MONITORING YEAR 4 ANNUAL REPORT

LONE HICKORY MITIGATION SITE

RE: Lone Hickory Mitigation Site – Monitoring Year 4 Report Draft
Yadkin River Basin – CU# 03040101 – Yadkin County
DMS Project ID No. 97135
Contract # 6897

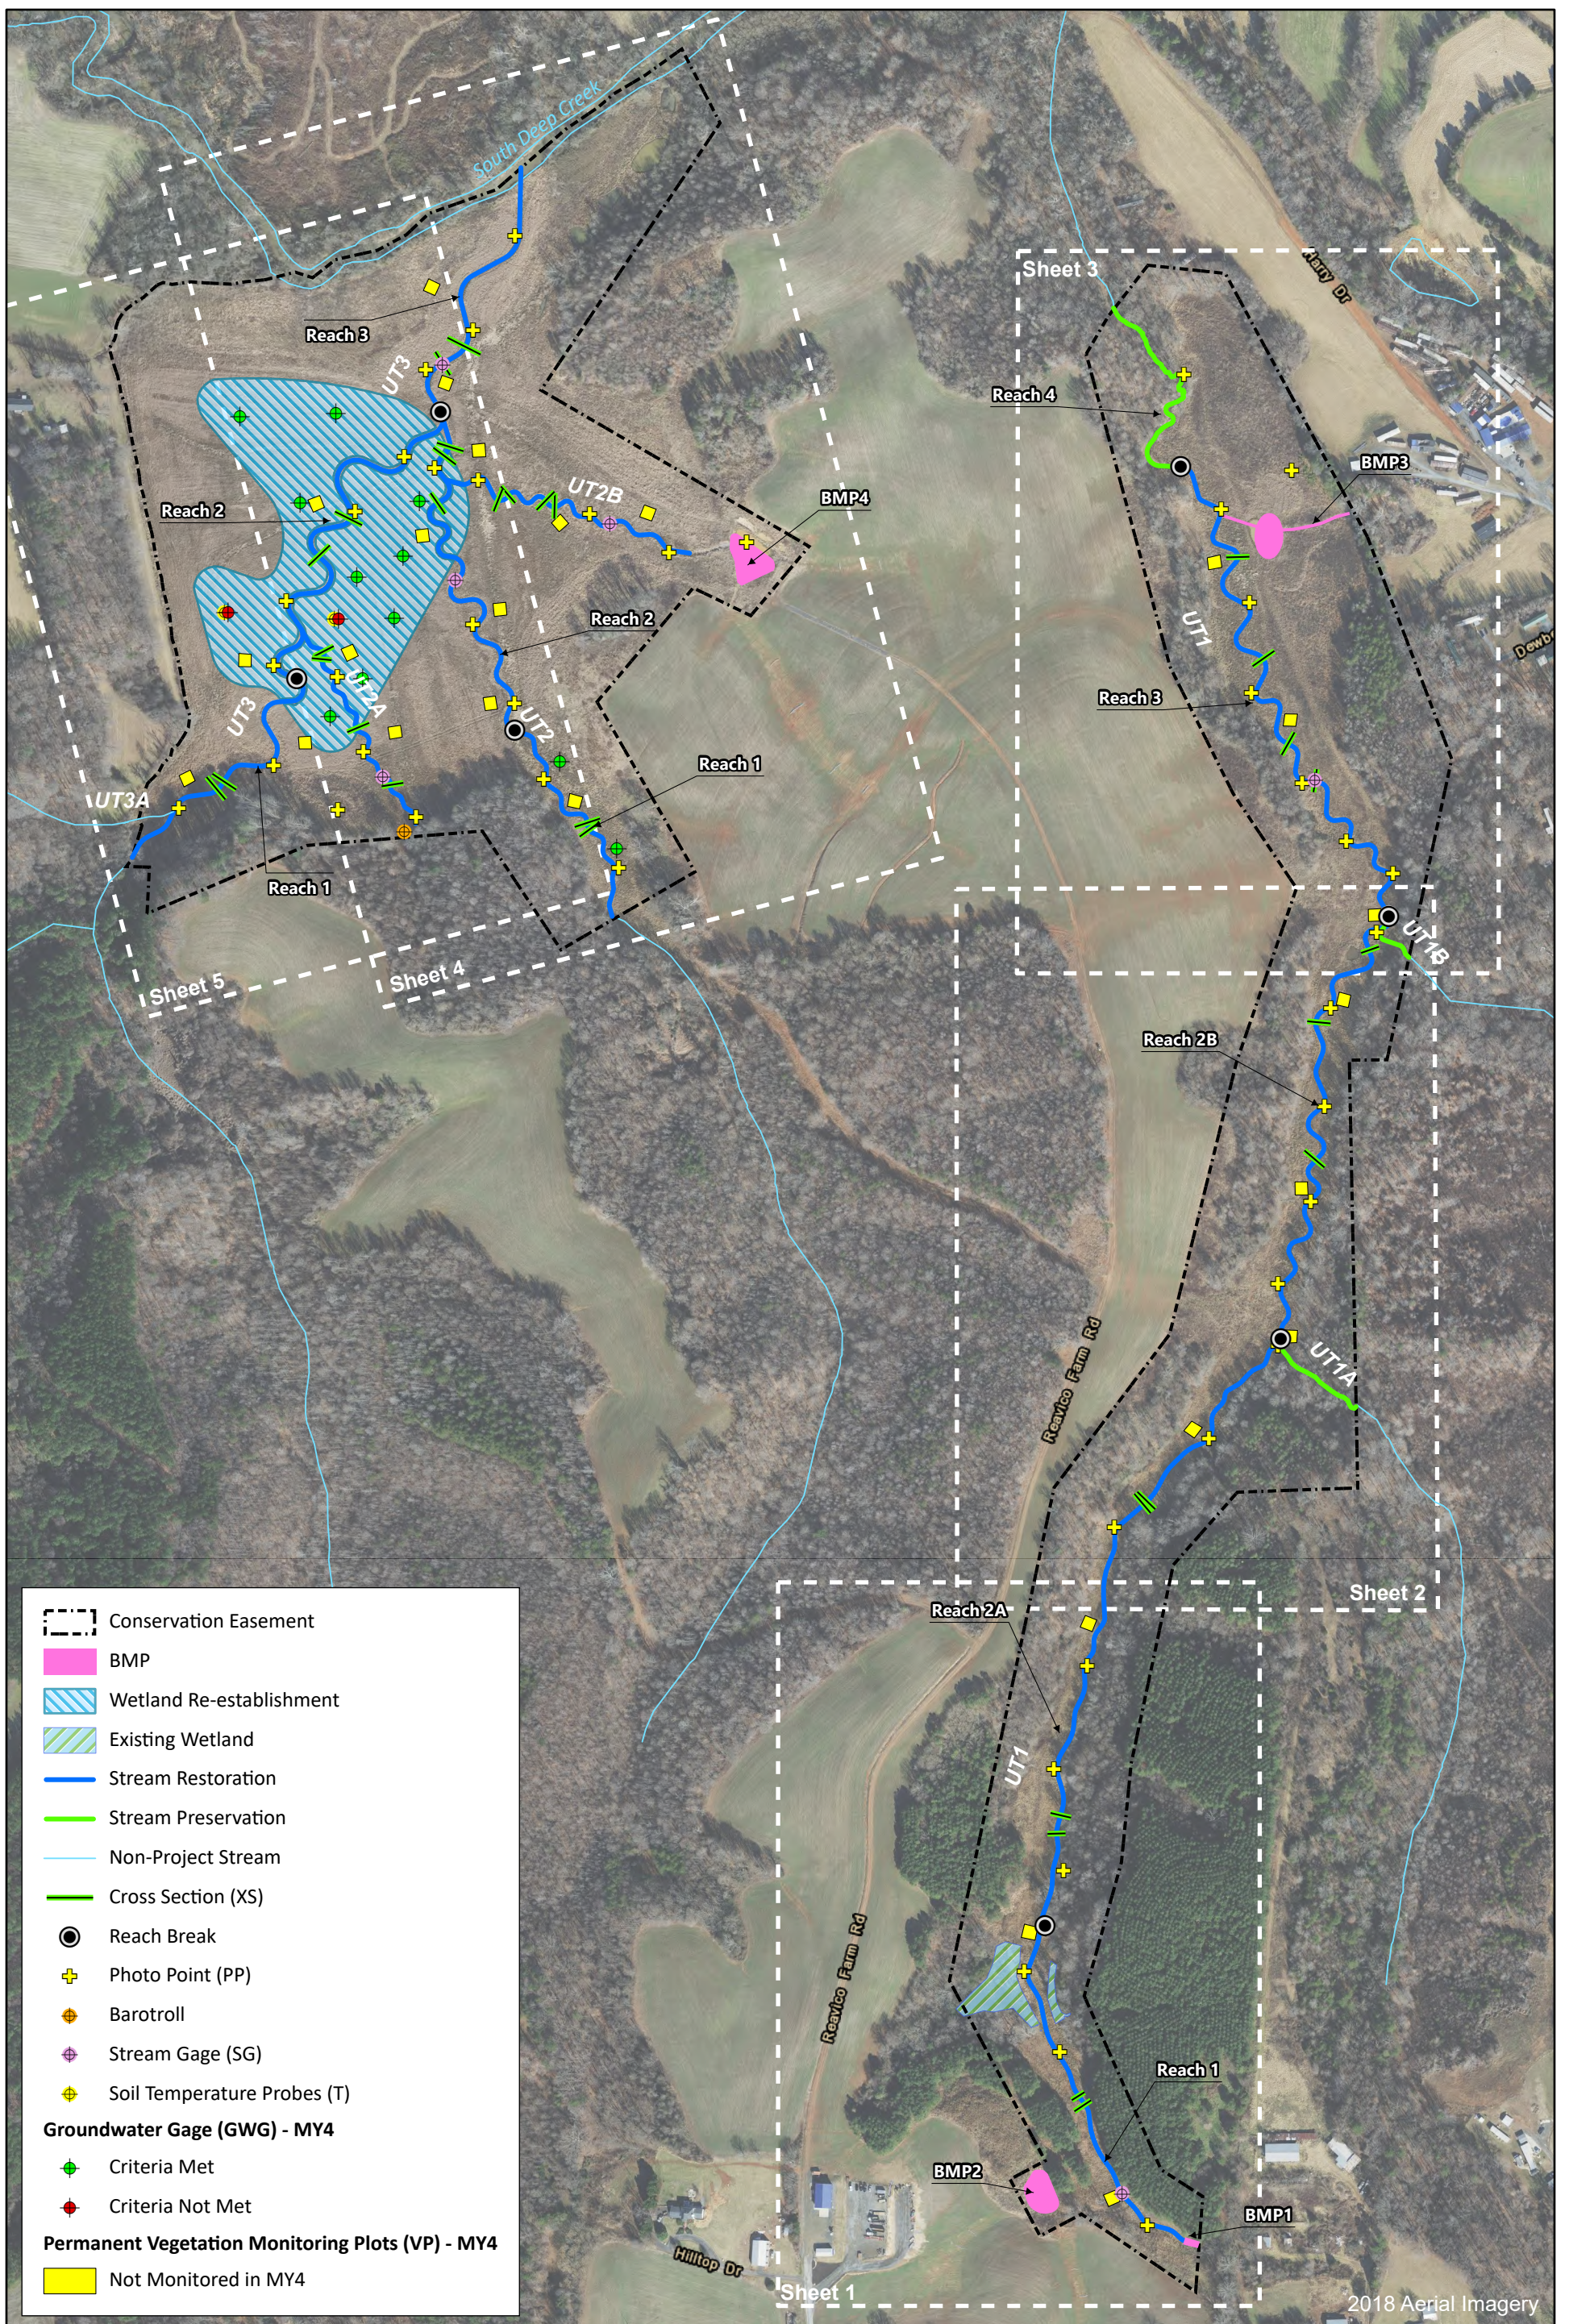
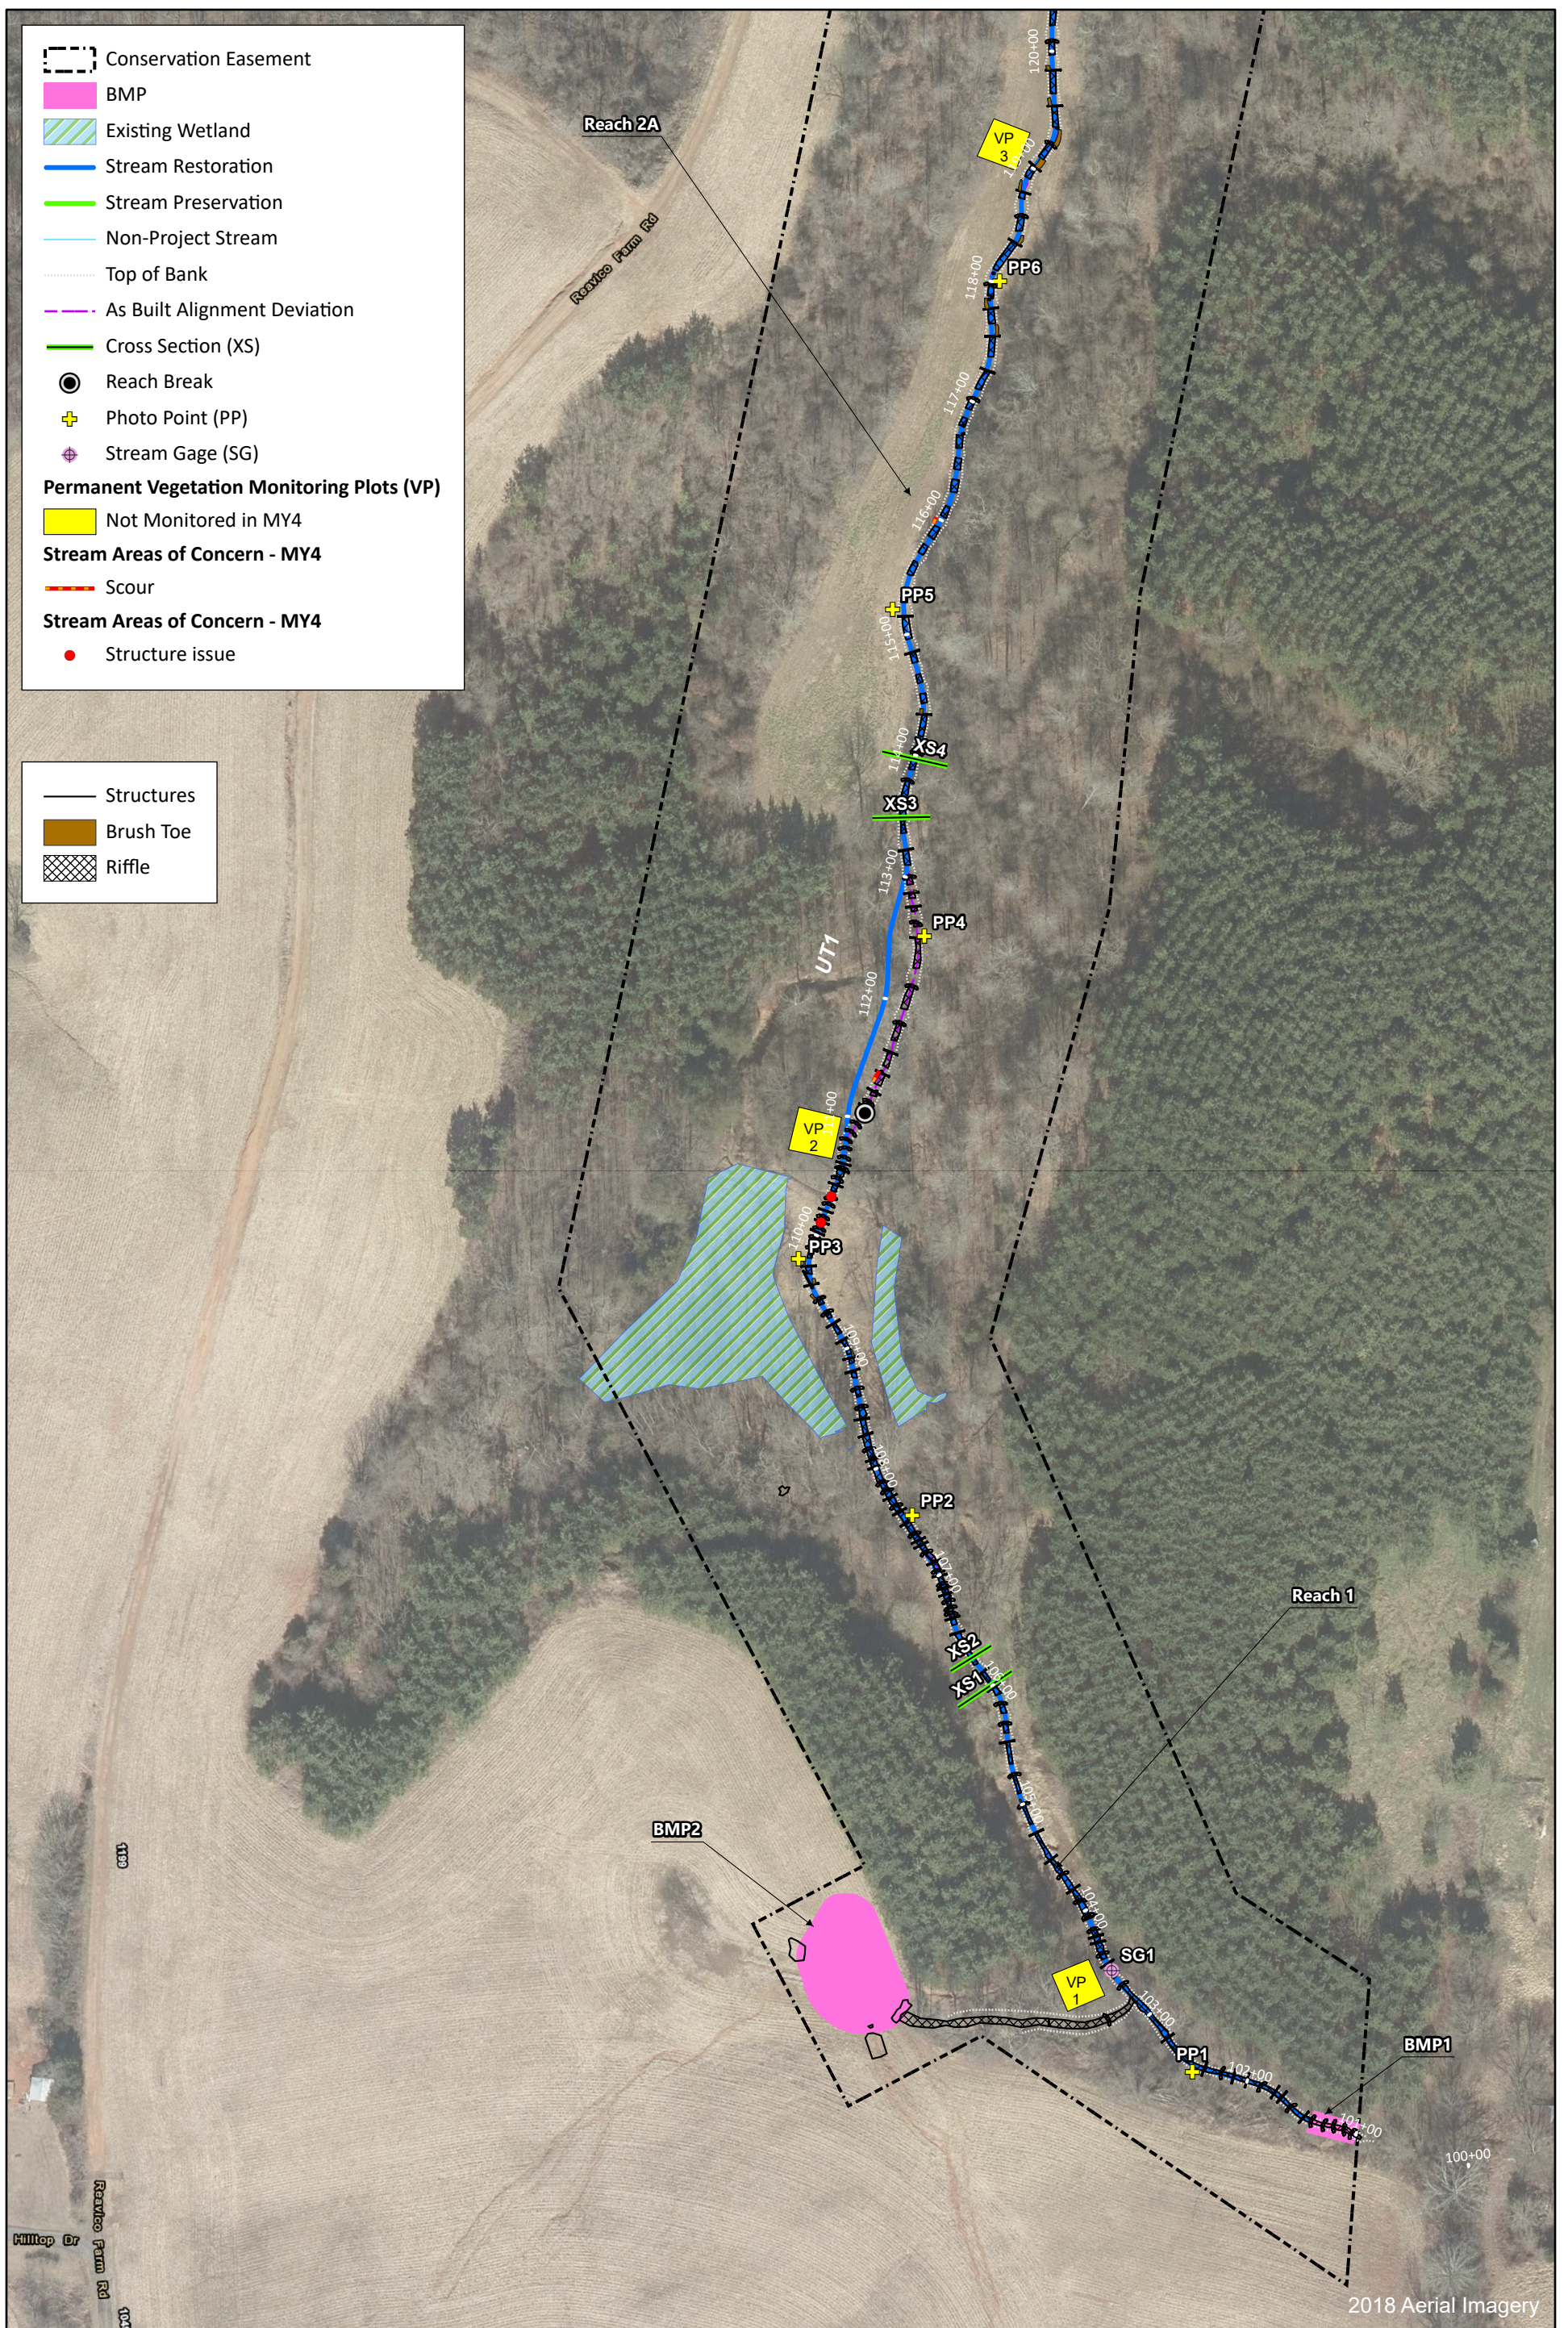
DMS' comment: CCPV Maps: Please show the two (2) established soil temperature probes on the applicable CCPV map sheets and update the digital support files accordingly.

Wildlands' response: The locations of the two soil temperatures probes have been added to the applicable CCPV figures. The digital GIS files have been updated to include the soil temperature probe feature class.
